## PORT OF WILMINGTON UPGRADES TO THE SOUTH GATE COMPLEX FOR

NORTH CAROLINA STATE PORTS AUTHORITY

Addendum #2

March 2, 2020

E-001

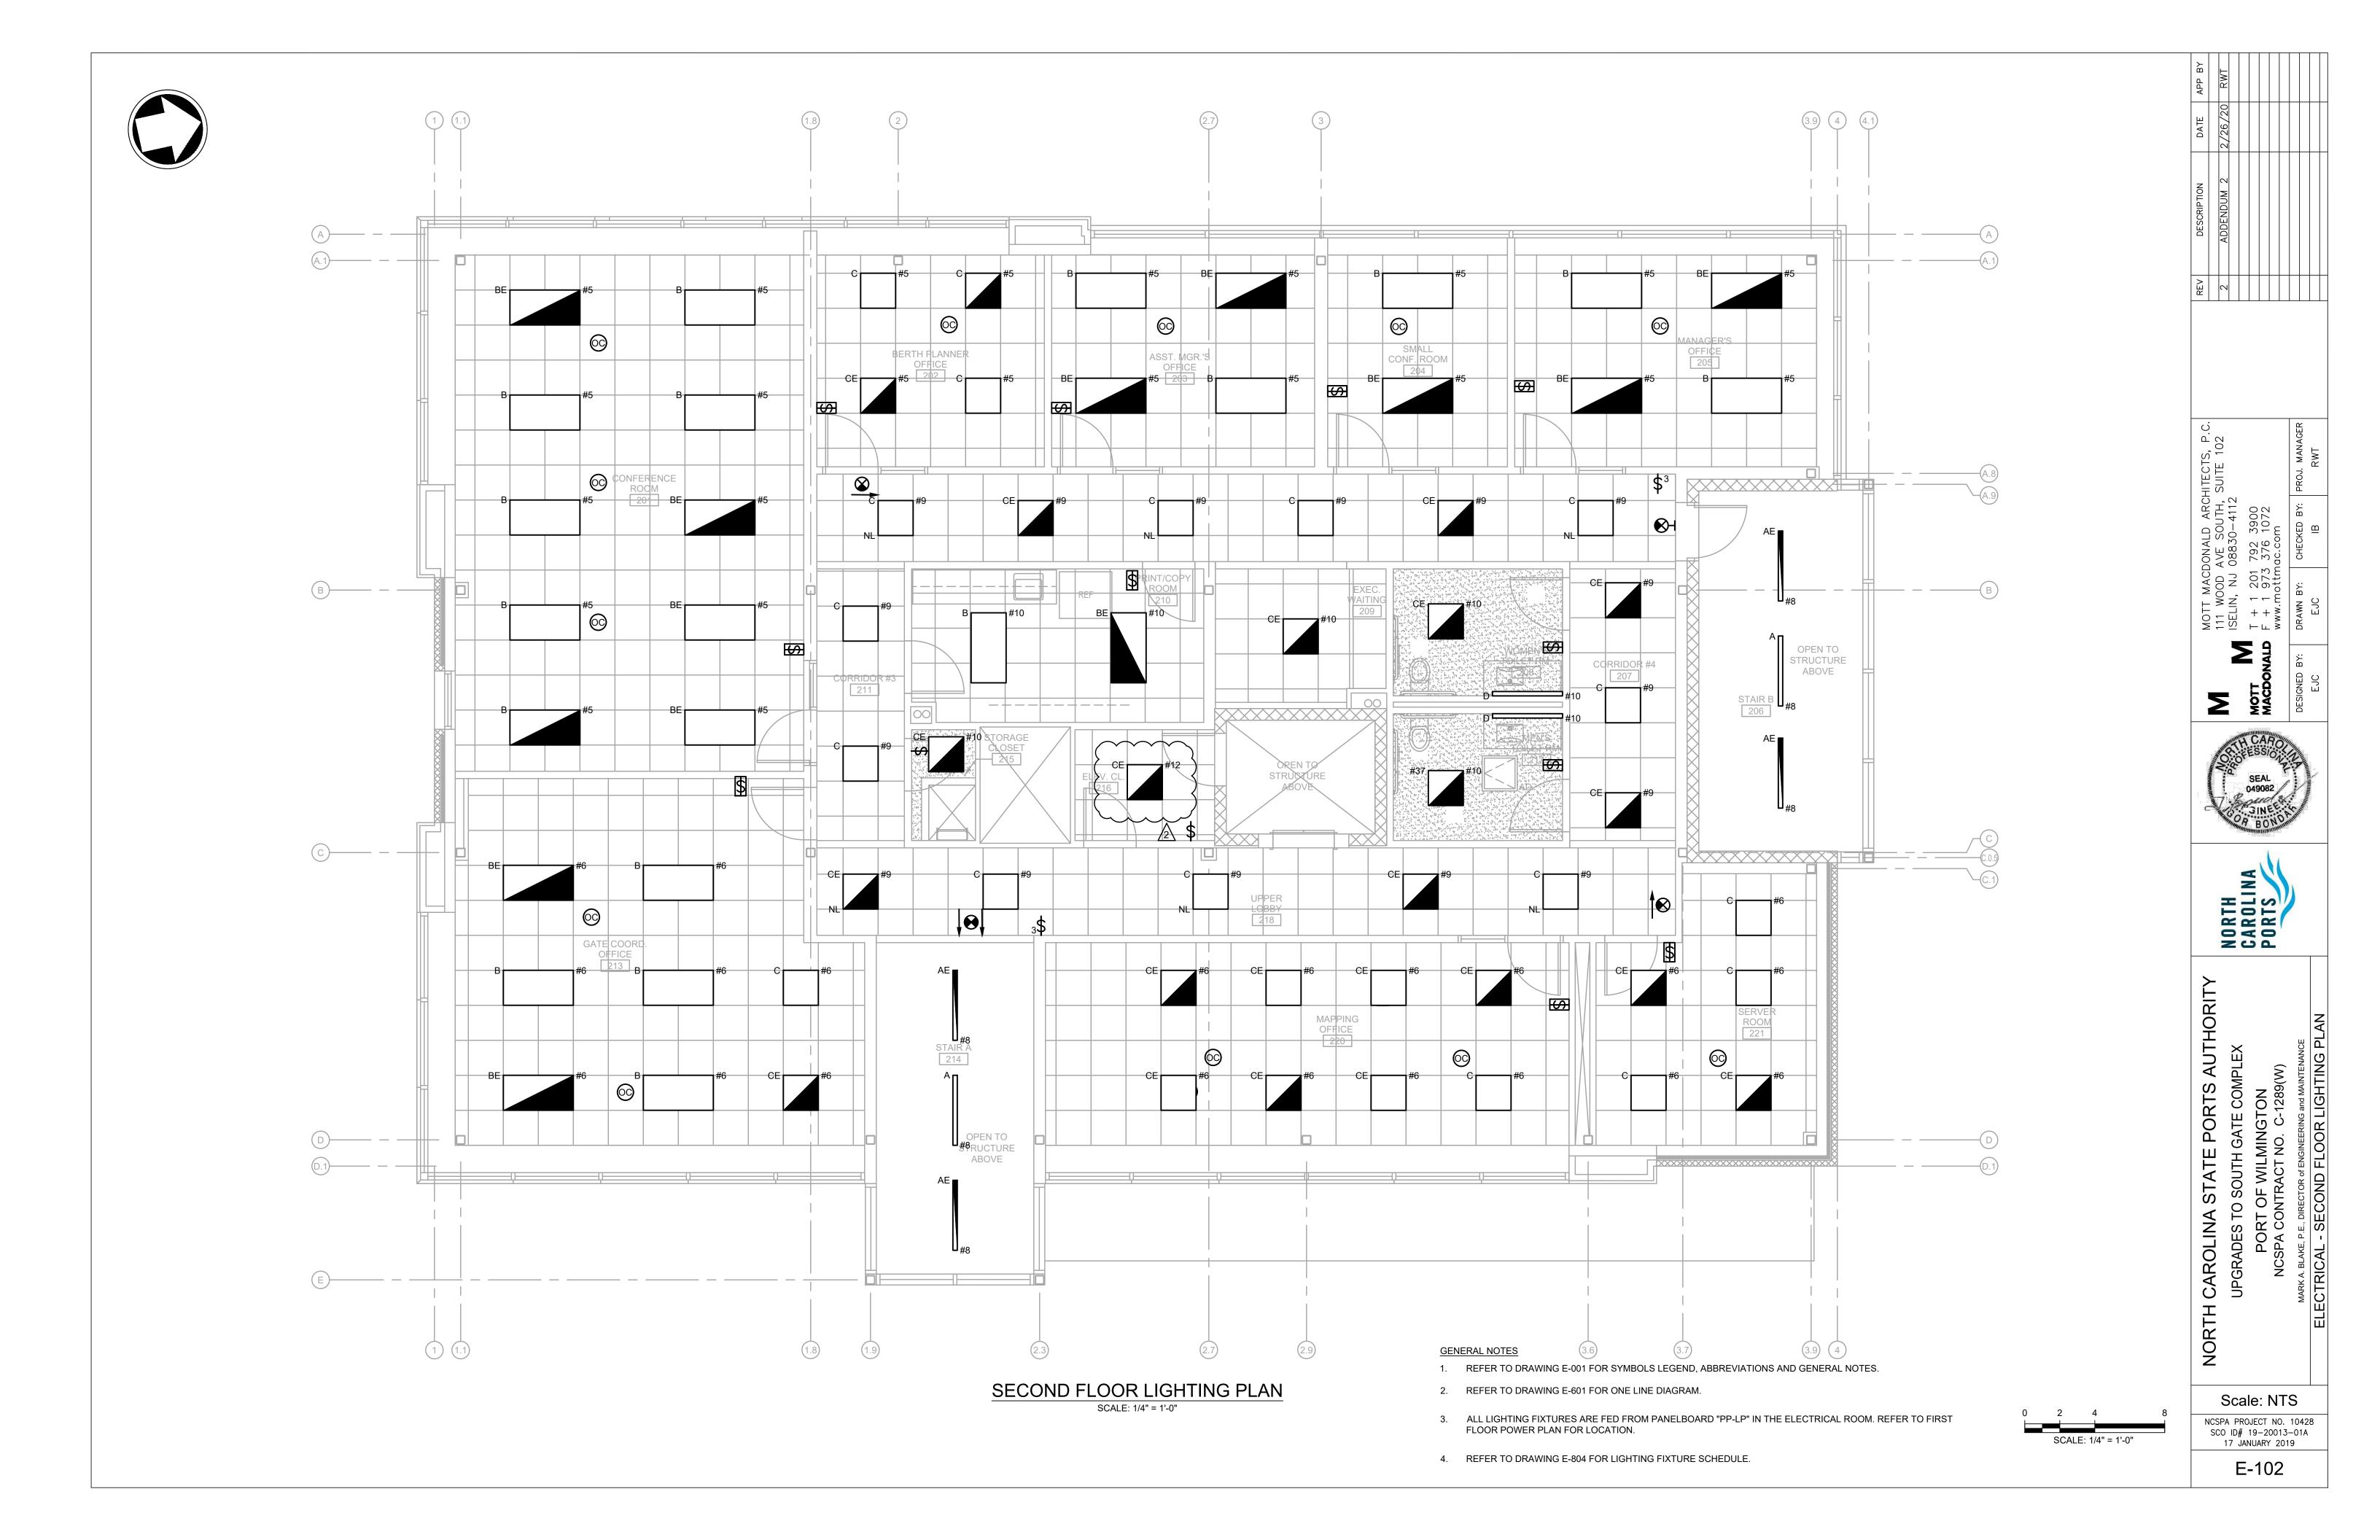
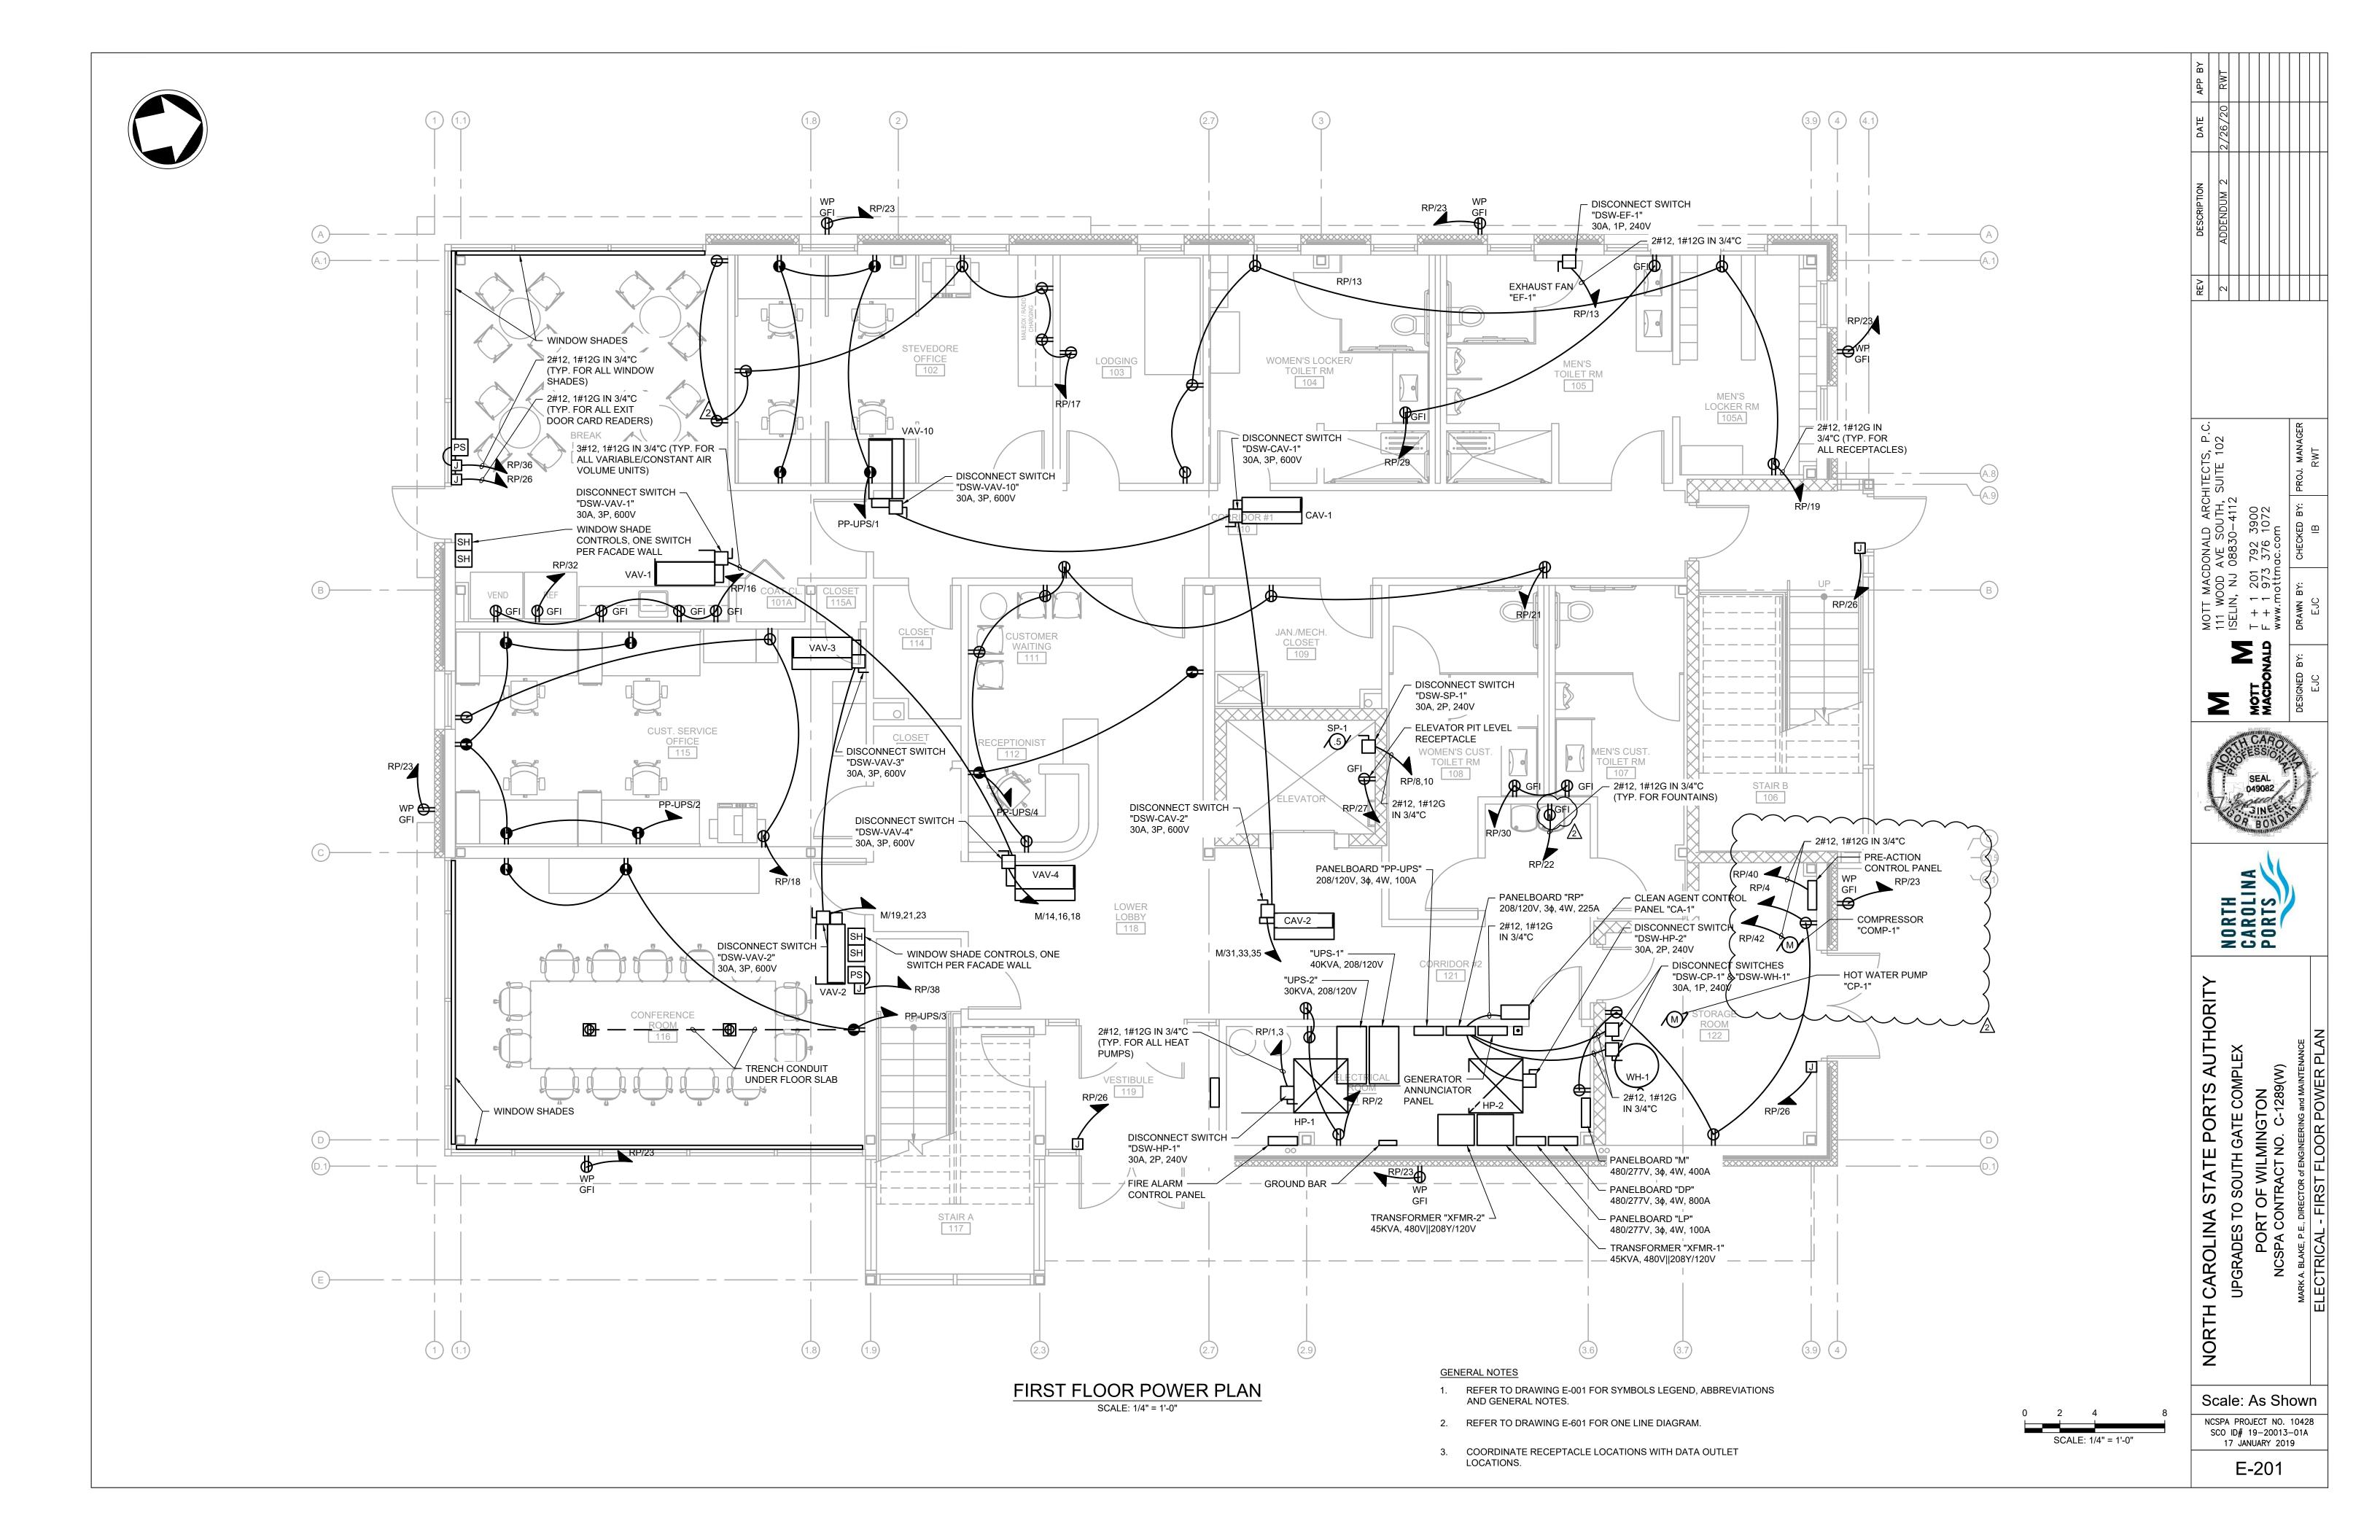
- q. PB034 Compressive Strength Mix
- 2. Revisions to Plan set:
  - a. CS-102
  - b. CS-103
  - c. CS-104
  - d. E-001
  - e. E-102
  - f. E-201
  - g. E-202
